Village of Arlington Heights
Plan Commission
Board Room
Arlington Heights Village Hall
33 S. Arlington Heights Road
Arlington Heights, IL 60005
May 25, 2016
7:30 PM

REPORT OF THE PROCEEDINGS OF A PUBLIC HEARING
BEFORE THE VILLAGE OF ARLINGTON HEIGHTS
PLAN COMMISSION

RE: LEXINGTON HOMES SUBDIVISION; PC# 16-004

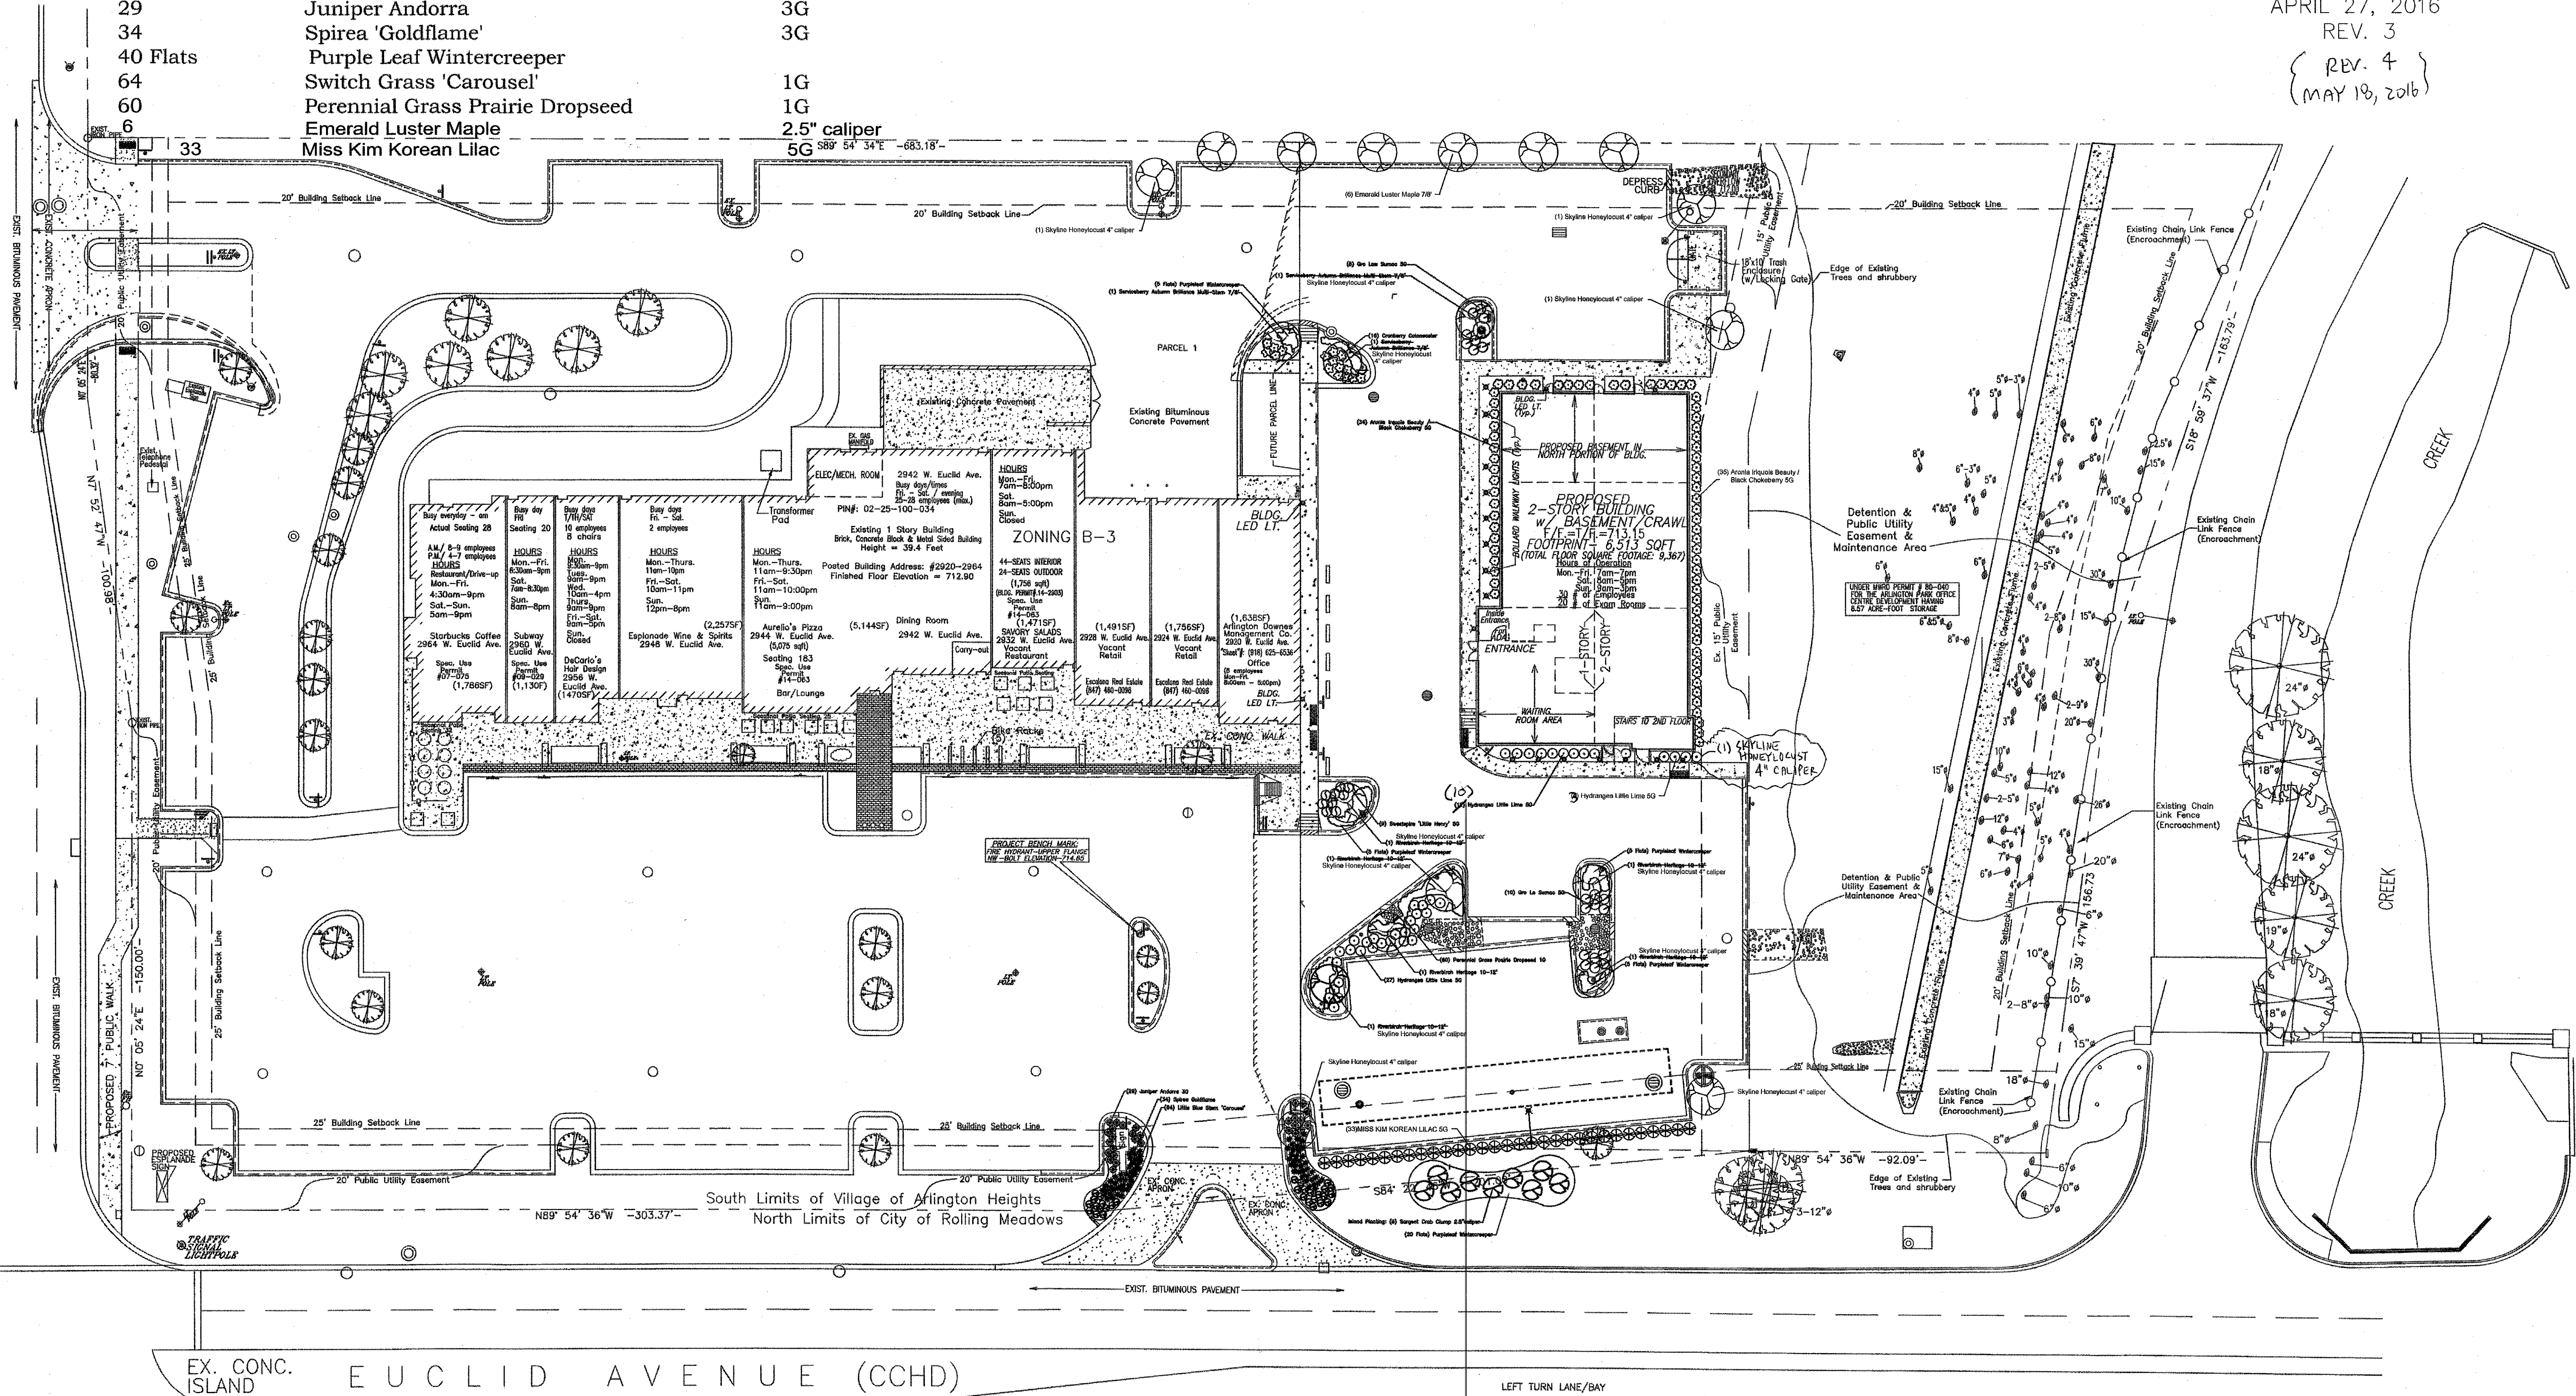
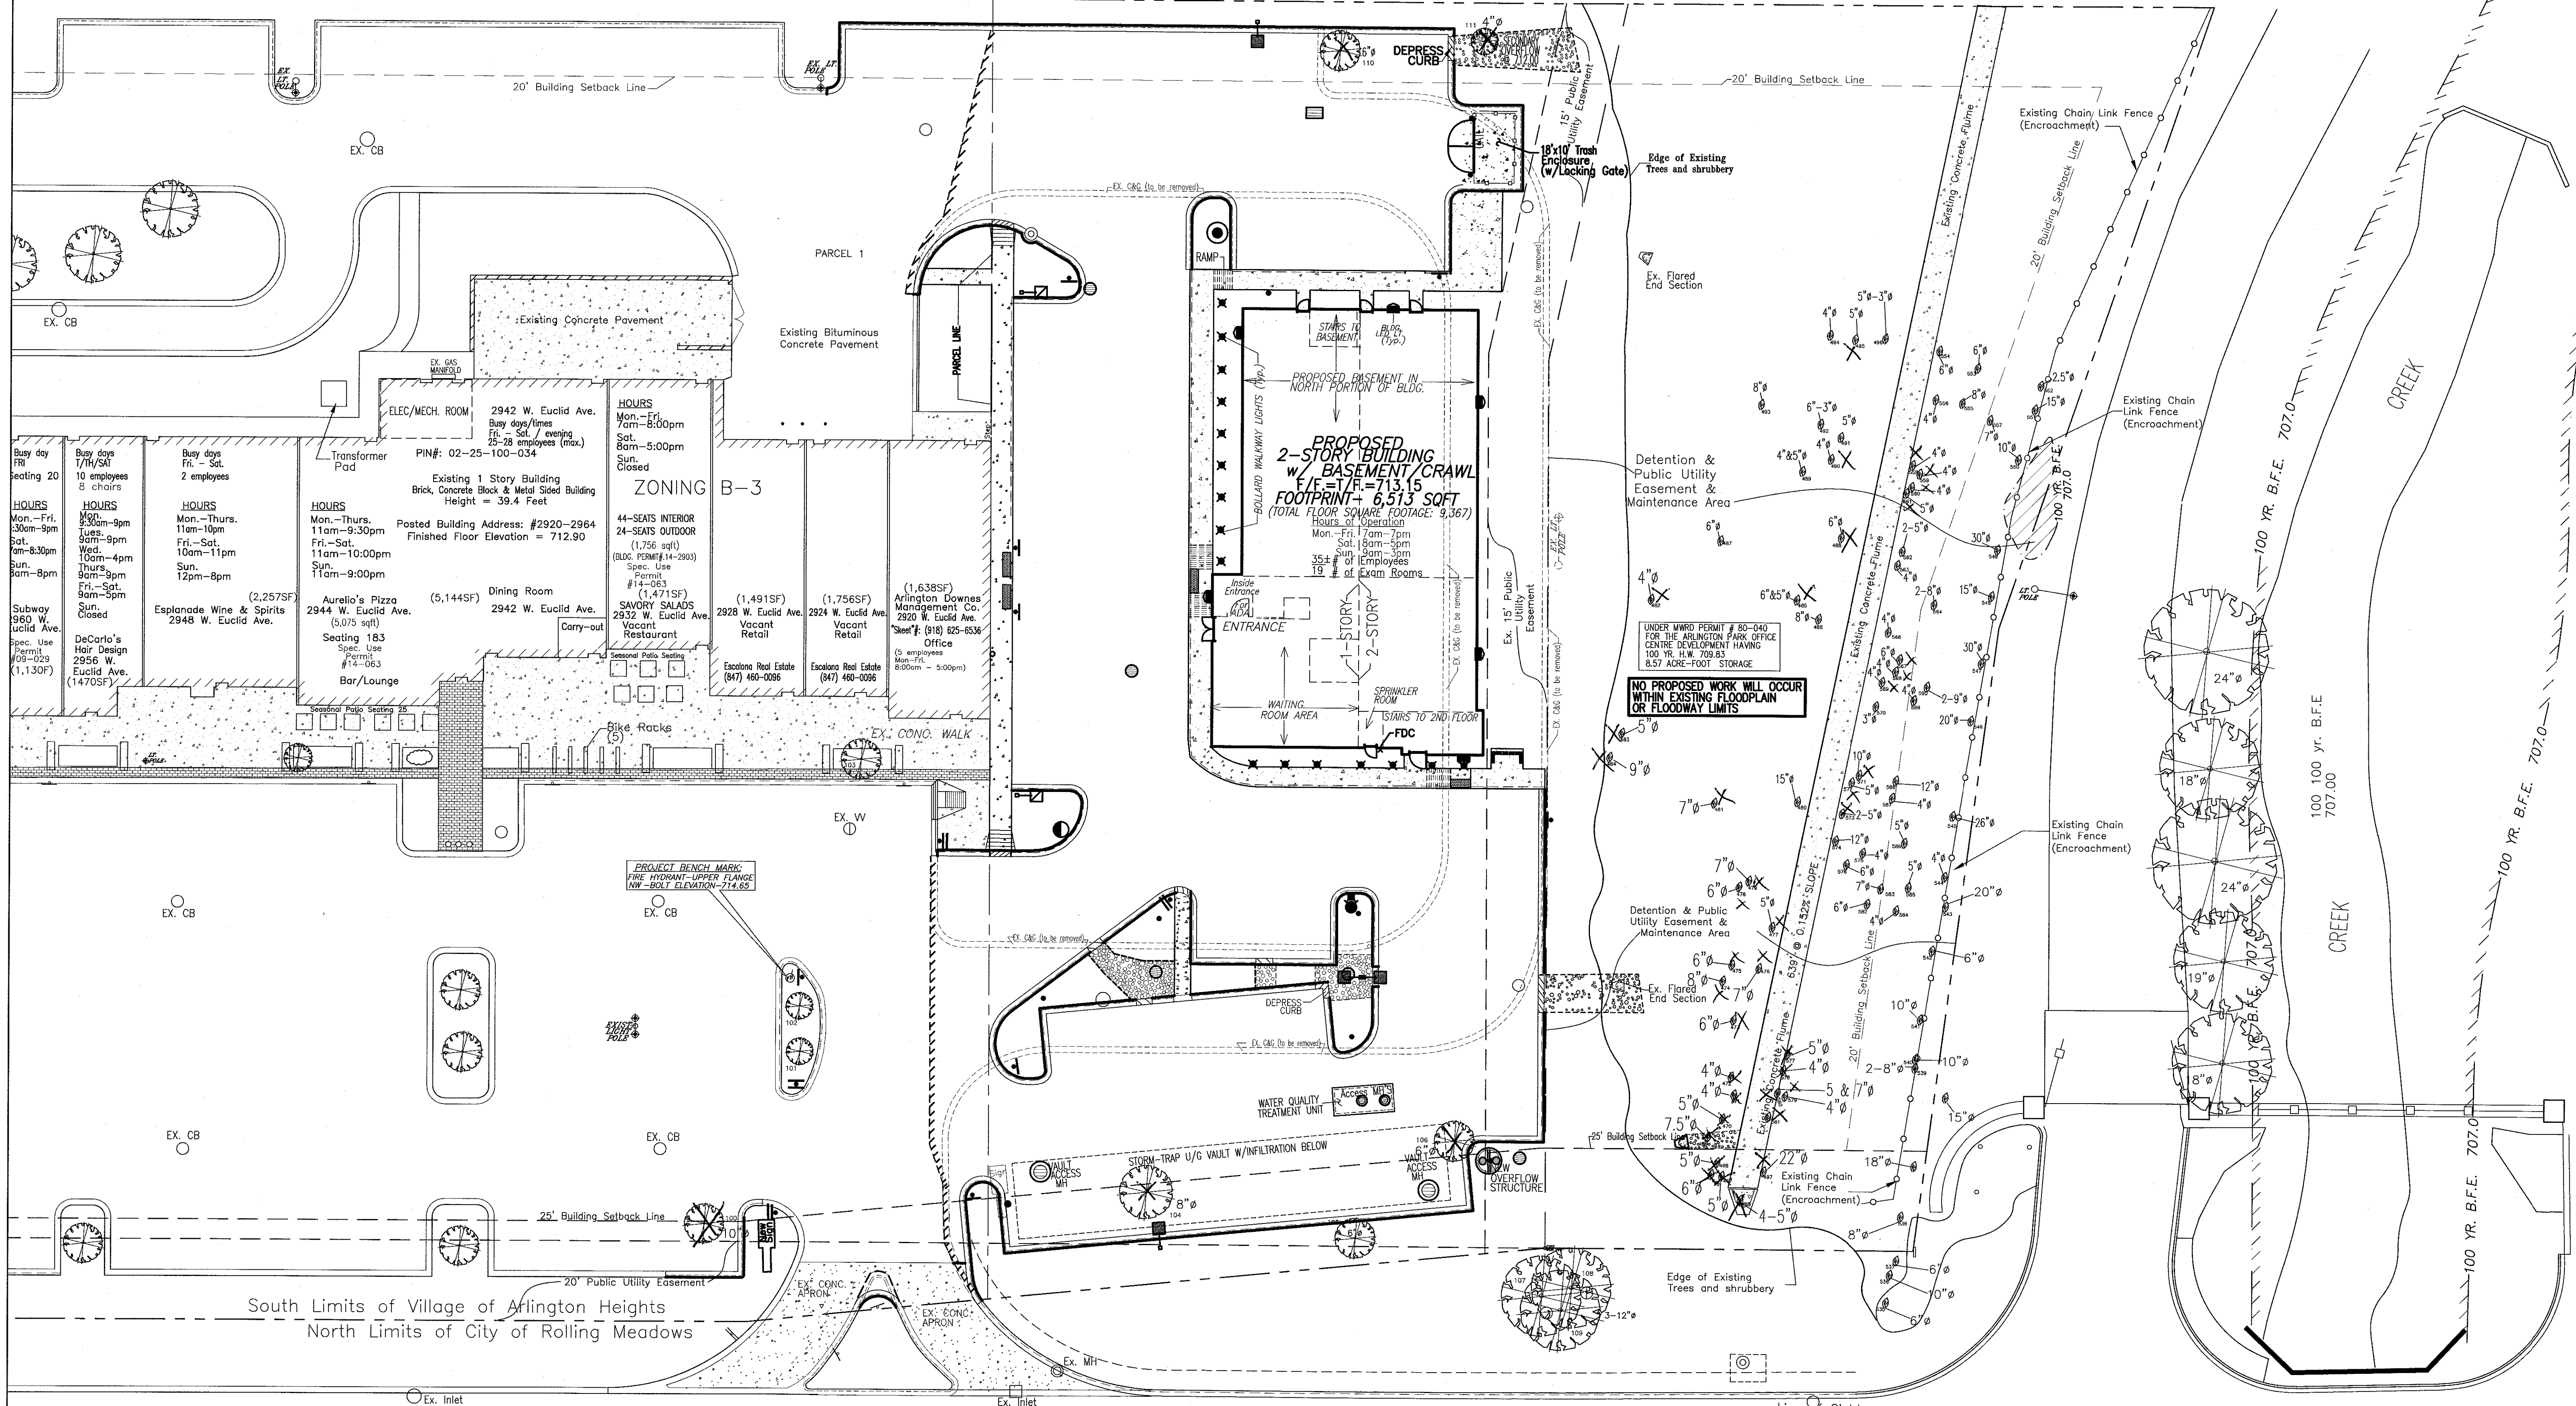
10. There are several existing trees located on Parcel II and shown on Sheet C-2 that are proposed for removal. However, these trees are not shown on the Tree Preservation Plan. Please revise the Tree Preservation Plan so that tree numbers are not blocked by the "X" that goes through the tree indicating it will be removed. Additionally, please revise the table to include a column indicating whether that tree will be removed or preserved. There are trees that will be preserved that are not shown within the table (such as the tree at the south end of the site by the parking area, which appears to be preserved but is not labeled with a number and included on the Tree Survey table).

10. There are several existing trees located on Parcel II and shown on Sheet C-2 that are proposed for removal. However, these trees are not shown on the Tree Preservation Plan. Please revise the Tree Preservation Plan so that tree numbers are not blocked by the "X" that goes through the tree indicating it will be removed. Additionally, please revise the table to include a column indicating whether that tree will be removed or preserved. There are trees that will be preserved that are not shown within the table (such as the tree at the south end of the site by the parking area, which appears to be preserved but is not labeled with a number and included on the Tree Survey table).
Applicant Response: The Demolition & Existing Topography Plan (sheet C-2) and Tree Preservation Plan (T-1) are consistent.
Staff Response: Plans are now acceptable. Thank you for revising the Tree Preservation plan to ensure consistency with the Demolition Plan.

10. The Demolition & Existing Topography Plan (Sheet C-2) and Tree Preservation Plan (T-1) are consistent.
11. [For Architect].
12. The photometric plans are updated to conform with requirements from section 11.2-12.5, and all luminaire fixtures are clearly indicated.
13. [For Architect].
